Powerlink Customer Panel – Comments on Draft Regulatory Proposal 2023-27

This document provides a record of discussions at a (virtual) meeting of the Powerlink Customer Panel held on 28th October 2020, without Powerlink representatives in attendance. Some details were updated following comments/explanations by Powerlink at the RPRG meeting on 29th October.

Figure 11.2: Drivers of revenue change

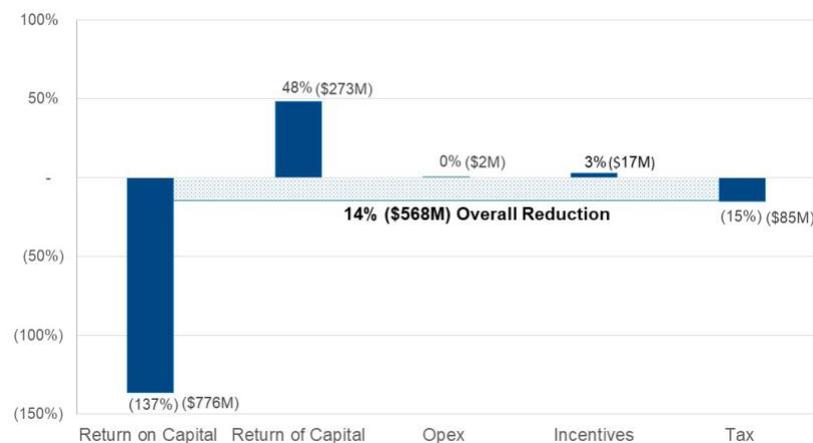
- While the proposed 12% price reduction is welcome, we are concerned that it is all due to falling WACC – with the same WACC as the current period, prices would increase 7% driven by higher depreciation. Given capex is predominately non-load driven replacement which has long asset lives, the increase in capex will lock in affordability issues for many decades and expose consumers to price rises when the interest rate cycle turns and WACC increases.

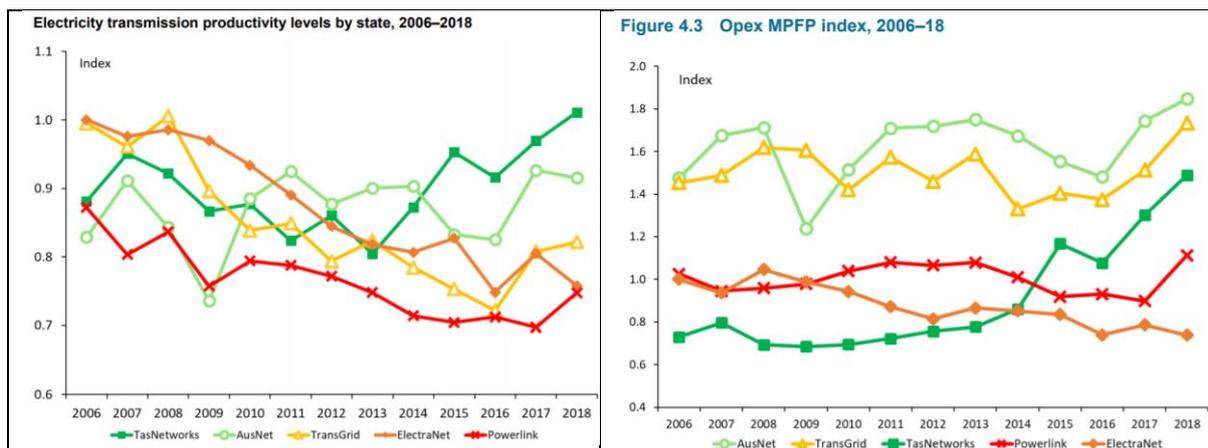
- Would encourage Powerlink to publish the HoustonKemp report – Appendix 4.01 – as soon as possible to enable CP feedback prior to finalisation of the Revenue Proposal
- Based on the latest published AER data, there was some improvement in 2017/18 but Powerlink is still 5 out of 5 in total productivity
- What is the forecast for the period to 2026-27 based on Draft Plan building blocks?

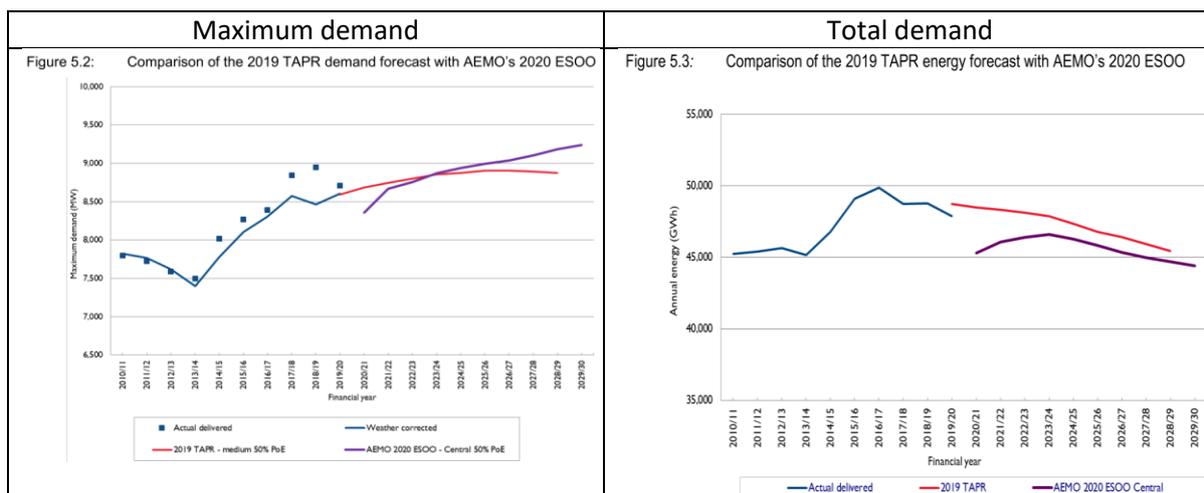
- AEMO forecast shows higher demand growth in maximum demand than 2019 TAPR ie after COVID
- How does this compare with 2020 TAPR? Reasons for differences?
- Up to the AER to assess demand forecasts – but seems optimistic eg assumptions on major loads in Queensland – coal/BSL?
